AEP:NRC:4321
10 CFR 50

SUBJECT: Donald C. Cook Nuclear Plant Units 1 and 2
Docket Nos. 50-315 and 50-316
Degraded Voltage Protection at Donald C. Cook Nuclear Plant

Response to U. S. Nuclear Regulatory Commission Request Regarding Degraded Voltage Protection

One Line Electrical Diagram – Donald C. Cook Nuclear Power Plant

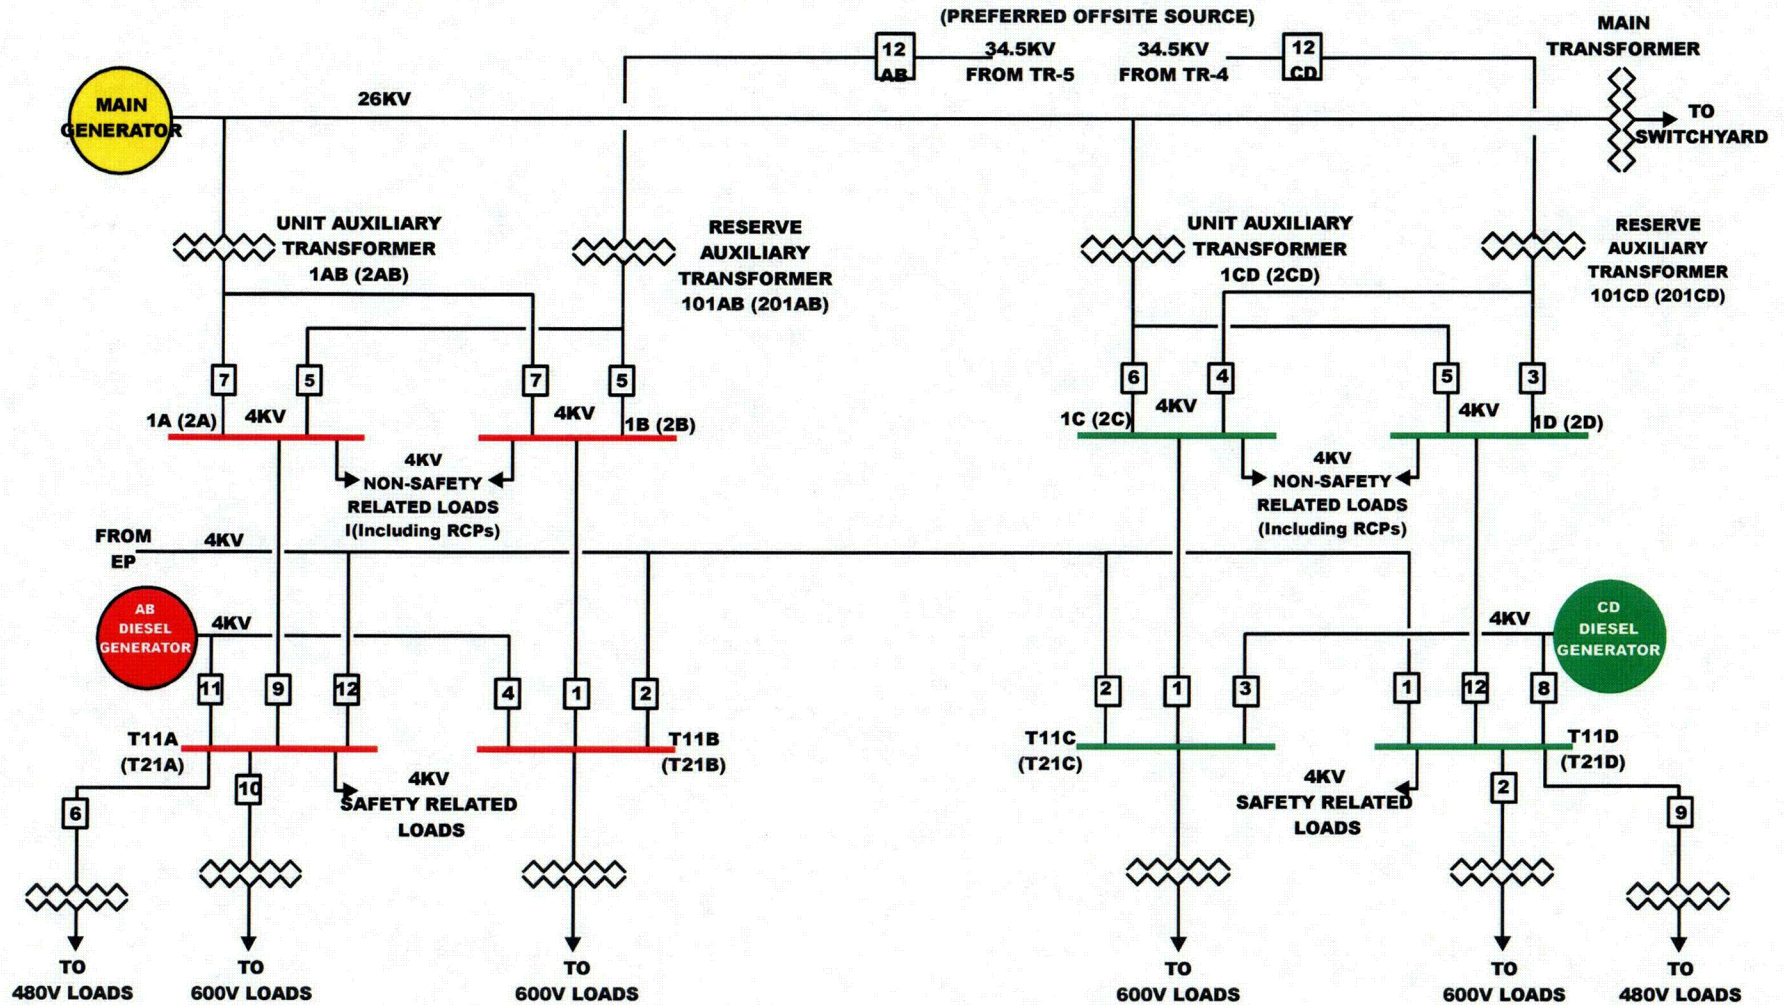
During normal operation potential degraded voltage conditions existing on redundant safety-related buses will not be automatically detected.

Degraded voltage conditions could result from (a) deficiencies in the equipment between the main generator and the safety buses, (b) from starting transients experienced during normal operating events not originally considered in the sizing of these circuits, or (c) from problems with the main generator and its excitation system.

With the degraded voltage protection bypassed, the potential exists for disabling redundant equipment important to safety if degraded voltage conditions exist. Under these conditions, the existing design may also result in rendering both offsite and onsite power sources unusable.

If degraded voltage protection is bypassed for the first 30 seconds of an accident and a sustained degraded offsite power condition exists, the permanently connected Class 1E loads (e.g., magnetic contactors for the motor operated valves) may be damaged and may prevent the associated motors from performing their safety functions.

The lack of degraded voltage protection when safety equipment is being loaded onto the safety-related buses following a reactor trip or safety injection signal may be a vulnerability with common mode failure potential for multiple safety systems.

Attachment 2 to this letter provides a simplified one-line diagram showing portions of the offsite and onsite electrical power systems involved in degraded voltage protection at CNP. In the following descriptions, the Unit 1 component numbers are stated followed by the corresponding Unit 2 component numbers in parentheses.

During normal plant operation (i.e., main generator supplying power to the transmission network), the 4 kilovolt (kV) non-safety buses 1A, 1B, 1C, and 1D (2A, 2B, 2C, and 2D) are powered from the main generator via the Unit Auxiliary Transformers (UATs) TR1AB and TR1CD (TR2AB and TR2CD). This configuration was acknowledged by the NRC in the safety evaluation (SE) for initial plant licensing (Reference 1). The 4 kV non-safety buses provide power to safety-related 4 kV buses T11A, T11B, T11C, and T11D (T21A, T21B, T21C, and T21D). In this configuration, the non-safety and safety-related 4 kV bus voltages are automatically controlled by the main generator voltage regulator through the UATs. Since the main generator voltage regulator automatically responds as needed to support nominal voltage on the transmission network, 4 kV bus voltage variations are opposite from those occurring on the offsite circuit, which is supplied by the transmission network. Therefore, due to the impedance of the main transformer, when the offsite voltage is below nominal, the main generator voltage will be above nominal, which will result in above nominal voltages on the 4 kV and lower tier buses.

As described below under "Accident Operation," the 4 kV buses would be transferred to offsite power via the Reserve Auxiliary Transformers (RATs) TR101AB and TR101CD (TR201AB and TR201AB) during a postulated accident. There are two features in effect during normal operation that provide assurance of adequate voltage when the 4 kV buses are transferred to the RATs. During normal operation, transmission network voltages are monitored and adjusted as necessary by the transmission organization using the Cook Plant Online Load Flow (CKOLF) program. The program determines expected voltages at the CNP switchyards assuming a trip of a CNP unit. Interface agreements with the transmission organization would result in notification of the CNP control room operators if CKOLF predicts that an unacceptable voltage would occur following a unit trip. This would result in declaring the offsite circuit inoperable, applicable TS Actions would be initiated, and actions would be taken by the transmission organization to restore adequate voltages. Additionally, the RATs have an automatic load tap changing feature that remains in effect during normal operation. This feature automatically adjusts the transformer taps to compensate for variations in offsite voltage, thereby assuring that the transformer output voltage will be adequate when the 4 kV safety-related buses are transferred to the RATs following an accident.

As described in Section 3.0 above, during normal operation when the 4 kV buses are supplied by the UATs, bus voltages are monitored at the 4 kV and 600 V levels. Upon detection of a degraded voltage, a control room annunciator actuates. Therefore, degraded voltage conditions existing on redundant safety buses will be automatically detected.

The current CNP design and operational provisions assure that equipment important to safety is not disabled due to degraded voltage during normal operation. As described in Section 3.0 above, the main generator voltage regulator automatically maintains the desired voltage during normal operation. Instrumentation continuously monitors voltages at the 4 kV and 600 V levels during normal operation, and operator actions to correct an unacceptable voltage are initiated in accordance with established annunciator response procedures. I&M considers that a failure of operators to take action in response to the annunciators is not credible. There is a high degree of confidence that the procedurally prescribed action of raising the main generator output voltage will be successful in restoring the 4 kV and/or 600 V safety-related bus voltages to acceptable levels. These design and operational provisions assure that a degraded voltage condition that would disable equipment important to safety would not occur.
